Post Office Remodeling

Flad & Associates, Inc.

Project No. 78122

JUNE 20, 1979

A-2

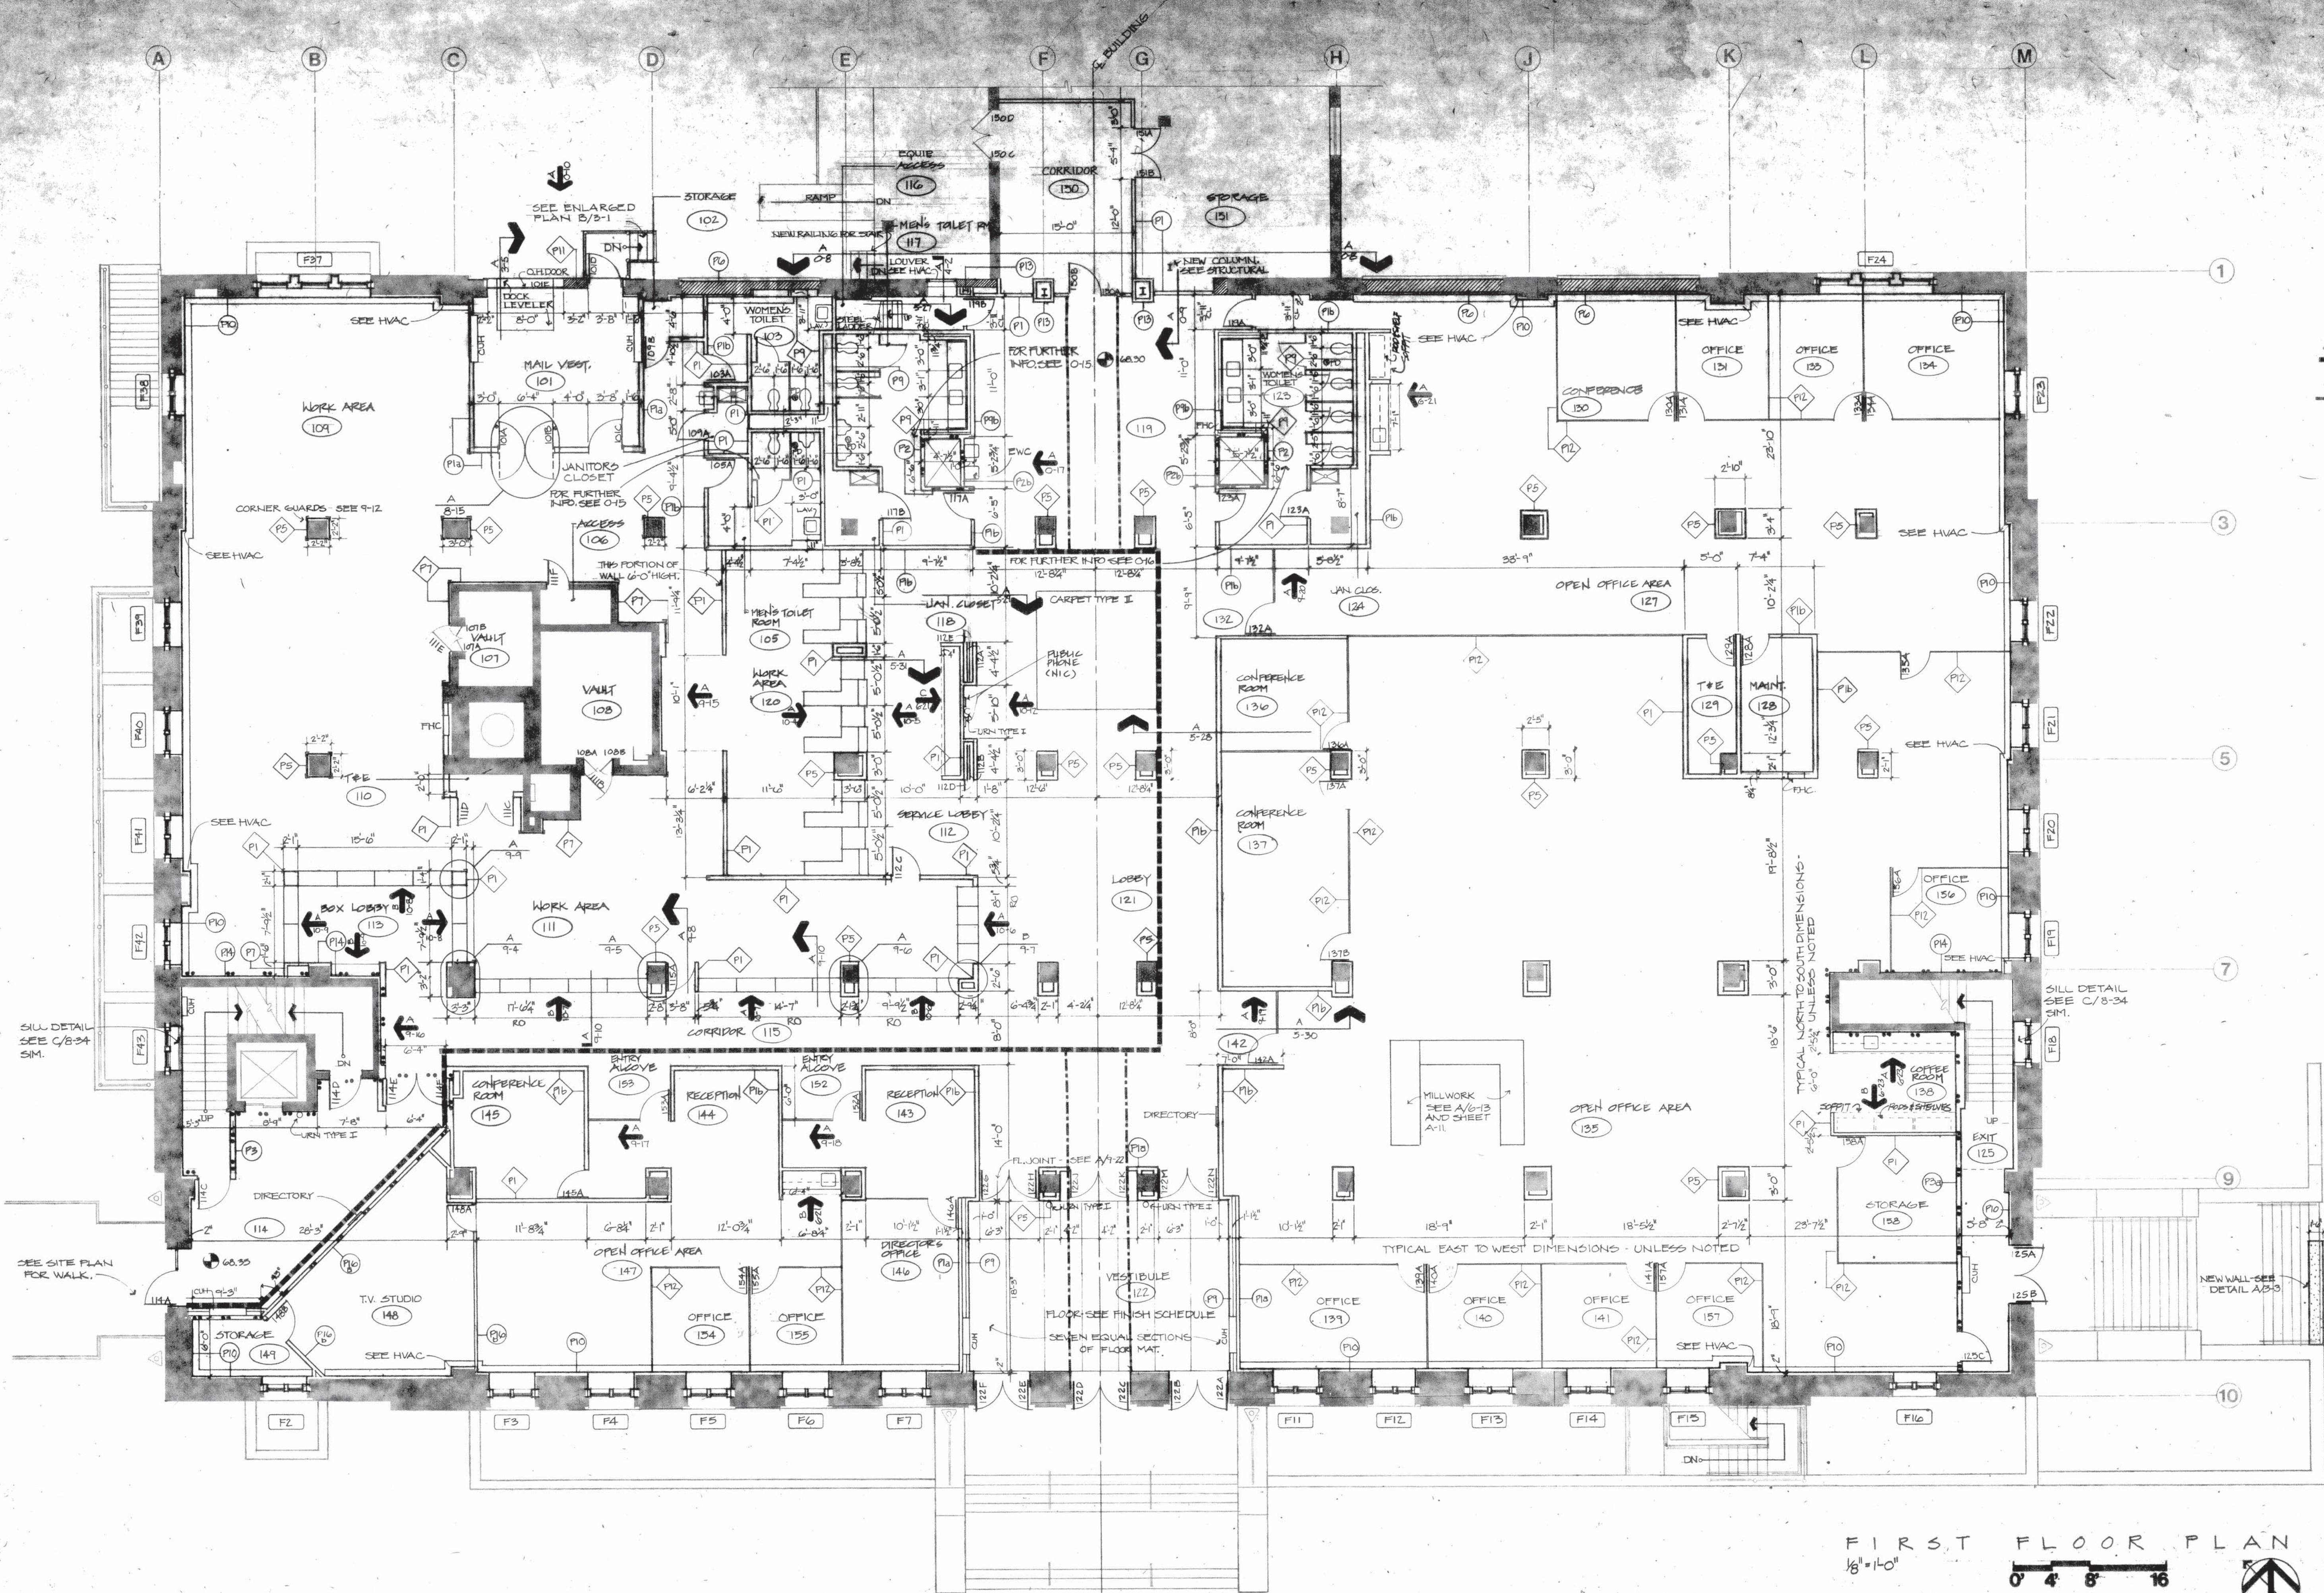
SHEET A-1
Exterior rail between walkway and drive at north side of building, add horizontal material to match existing as required so as not to allow a 9" sphere from going through the existing railing full length of the rail.

SHEETS A-1 and A-2
Exterior stairs to north of building, remove existing railing and install two rails each stair as shown on Detail 5-37.

Sheet No.
S-2

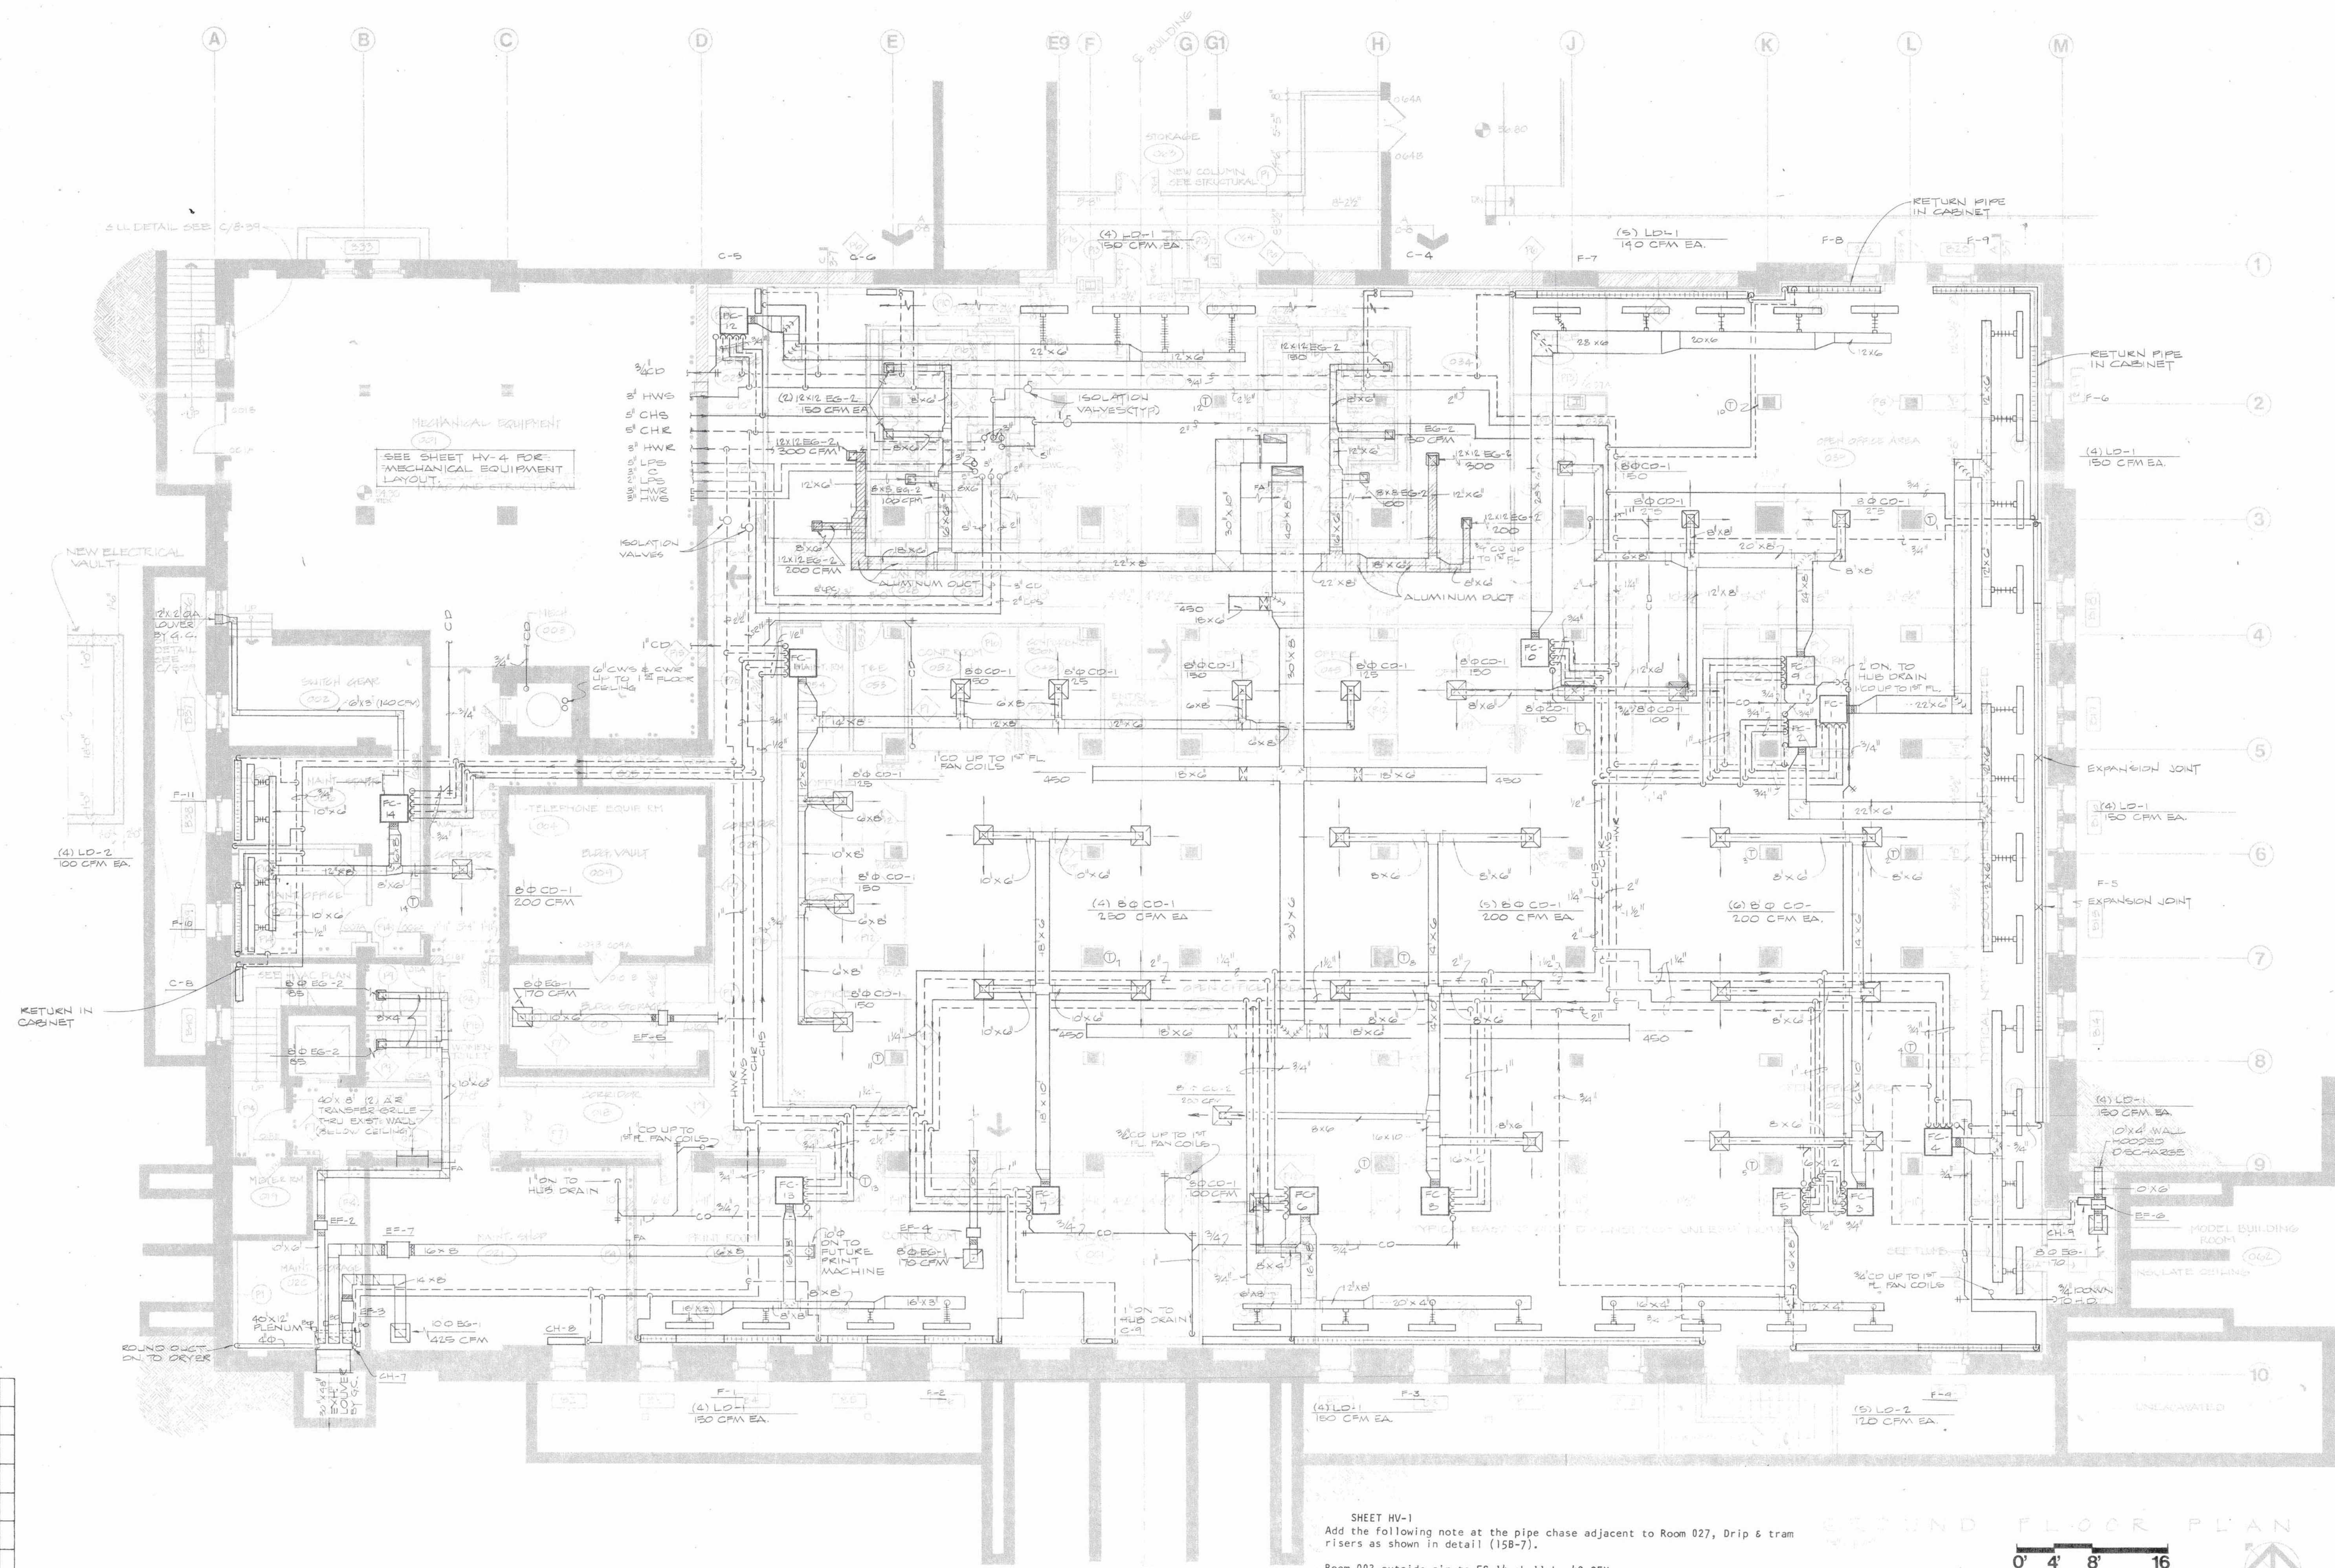
Room 003 outside air to FC-14 shall be 40 CFM.

Room 021 add a class A fire damper to the 40 x 18 air transfer grille.

Room 020 add a flexible connections to the outlet side of EF-3.

Room 23 at FC-12 change (2) 90° elbows in duct to (2) 45° elbows.

Rooms 24 & 34 change aluminum duct to sheet metal duct.

Sheet No.
HV-4

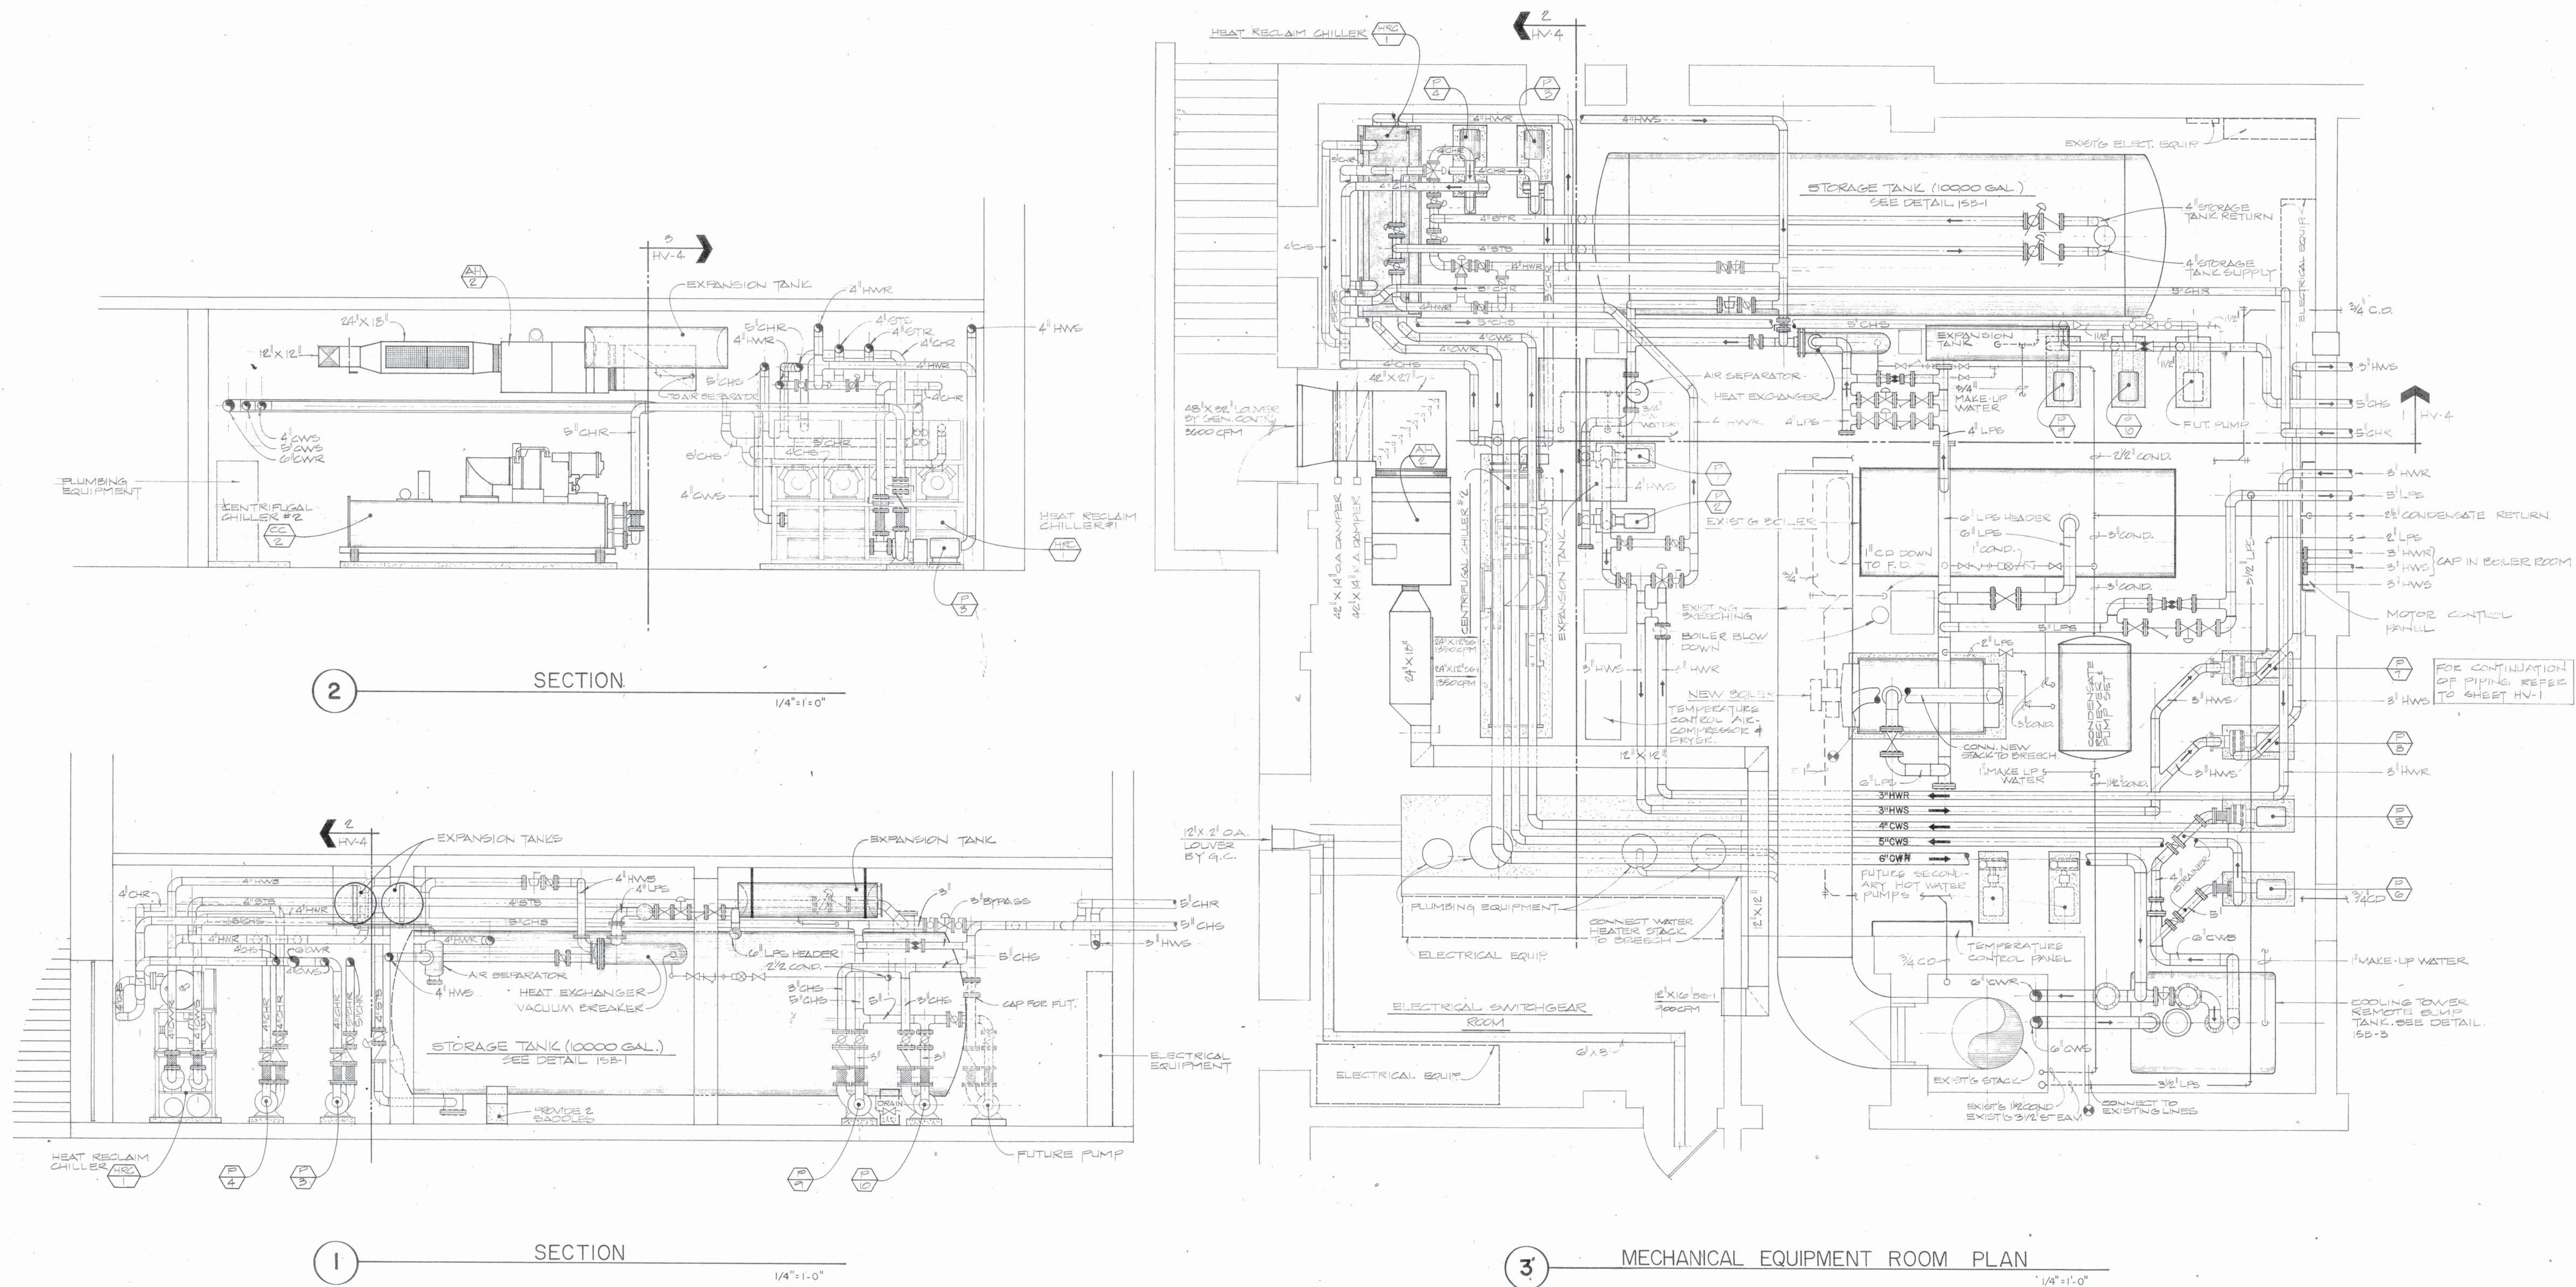
SHEET HV-4 Section 1
Change note at storage tank to read, "Provide 4 saddles."
See sheet A attached for gas piping in mechanical equipment room.
